**ADDENDUM #1
TO
SPECIFICATION AND CONTRACT DOCUMENTS**

May 15, 2014

FOR: ITB-021-2014
Metal Roof Overlay – Sprayfield Pole Barn

A. SCOPE OF WORK:

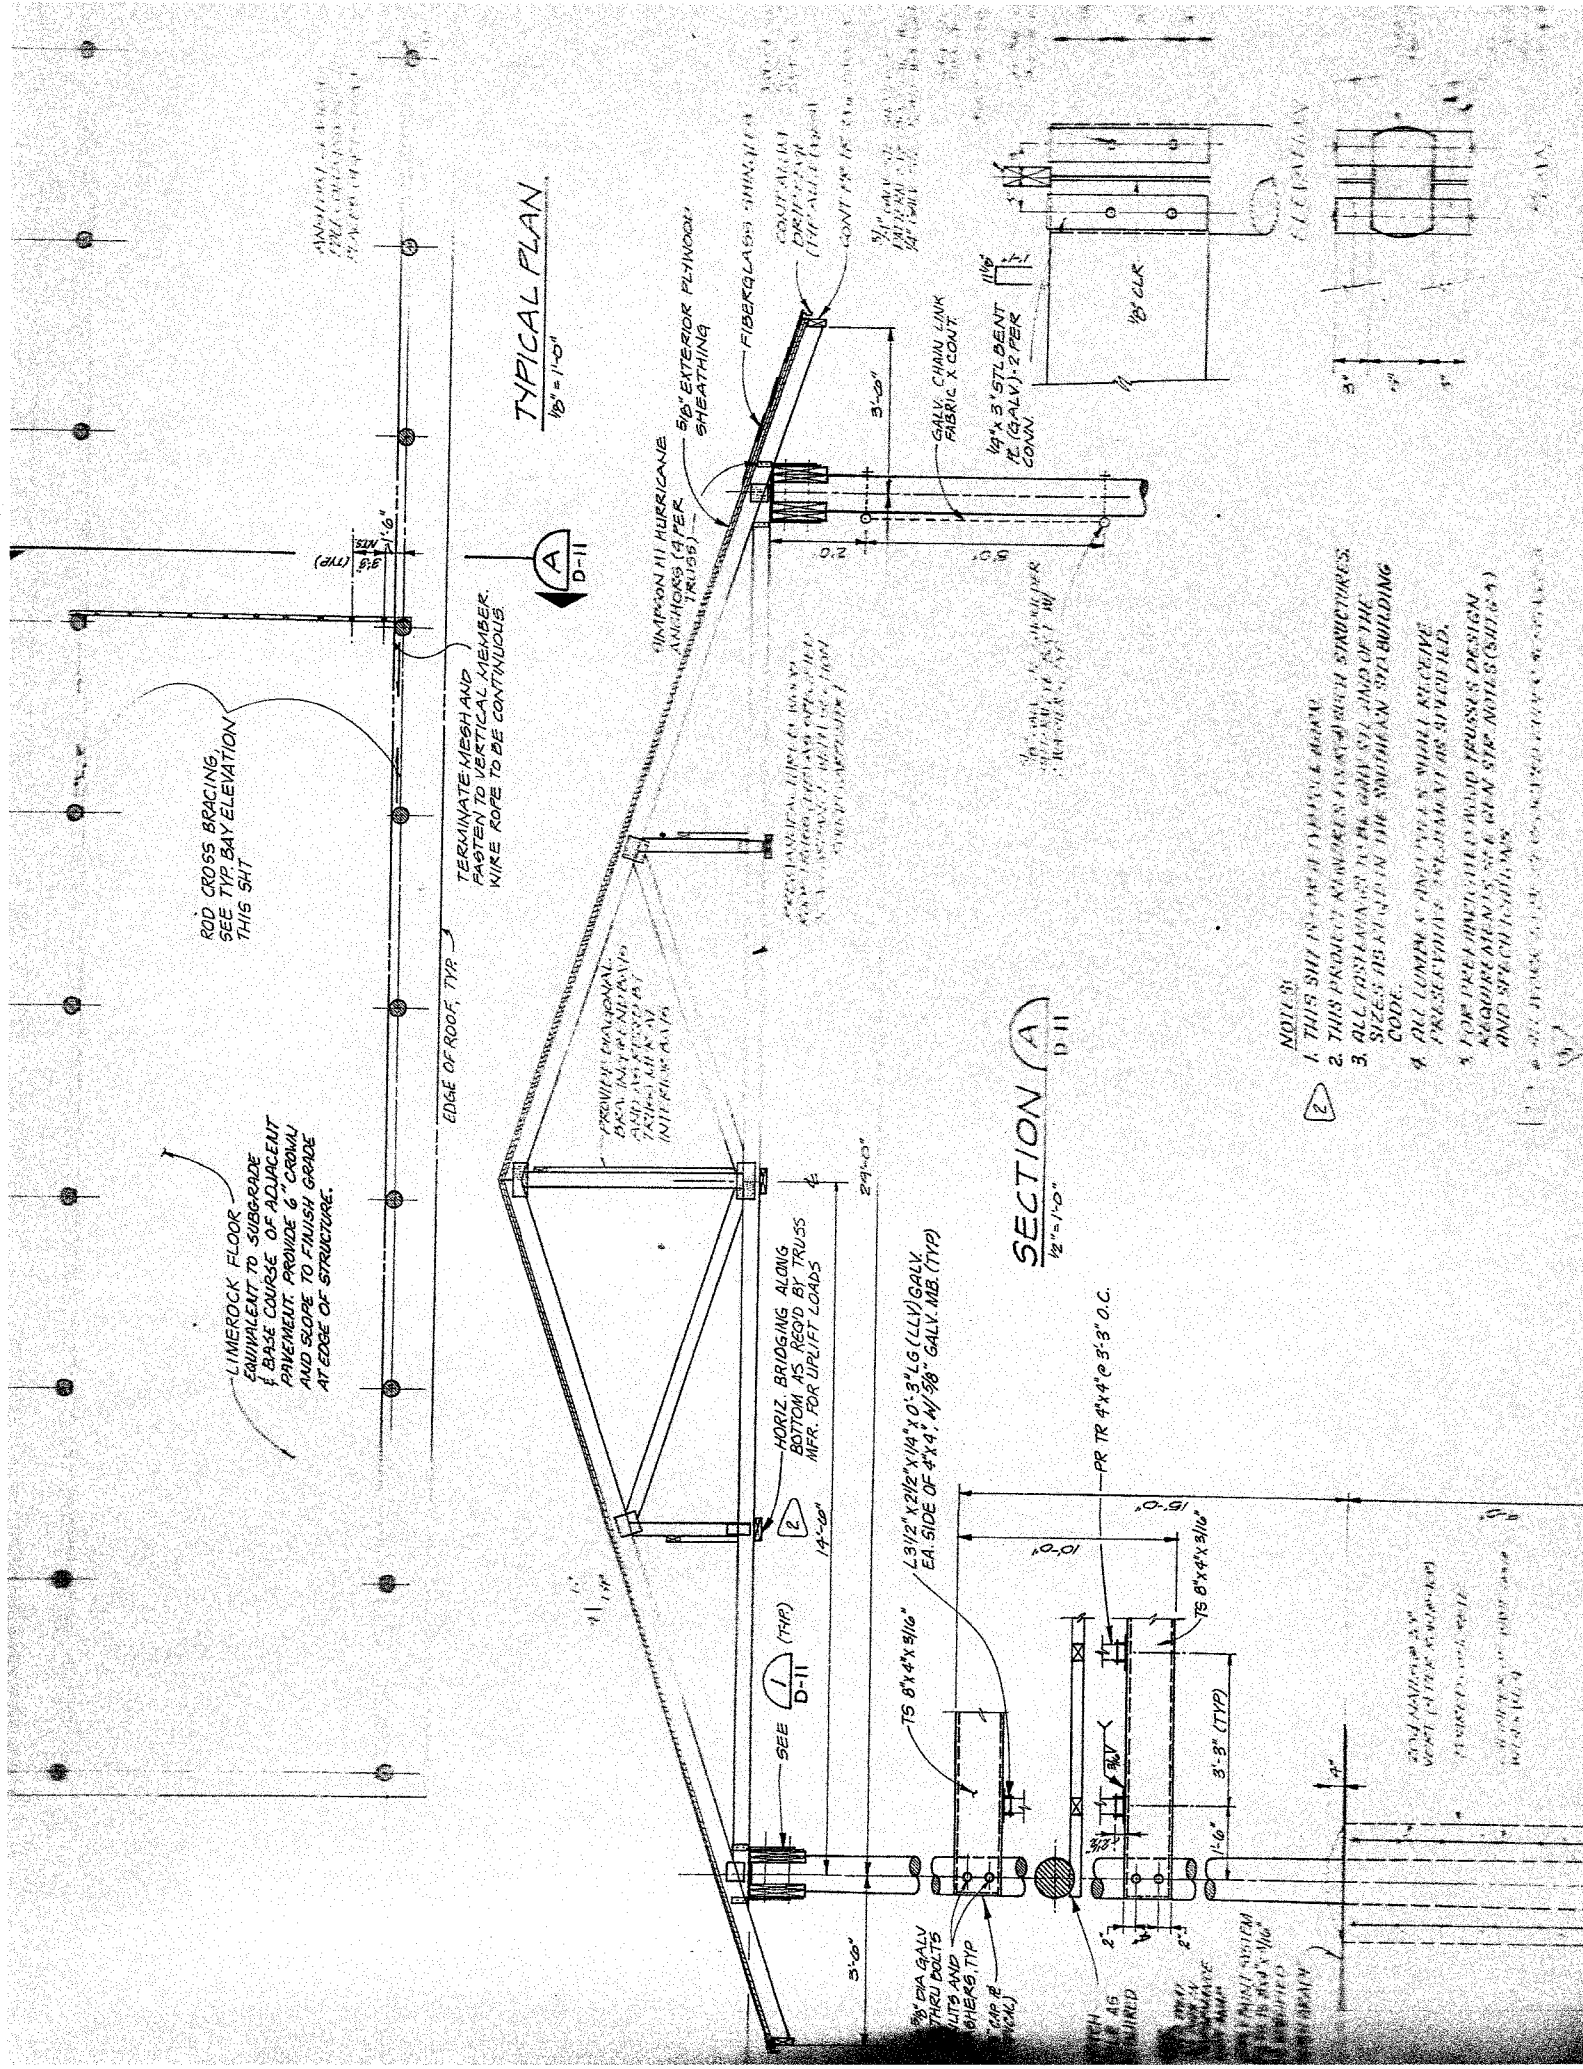
1. Remove 2 x 6 facial boards and replace with new 2 x 4 facial.
2. Replace rotten plywood as needed.
3. Install metal to cover plywood on both gable ends.
4. Install 29 gauge galvanized roof panels over pine 1 x 4 on 24" center with new flashing, eave drip, and ridge cap.
5. Metal on the east gable end to extend 8' from the peak.
- 6. The roof pitch shall be 4:12.**
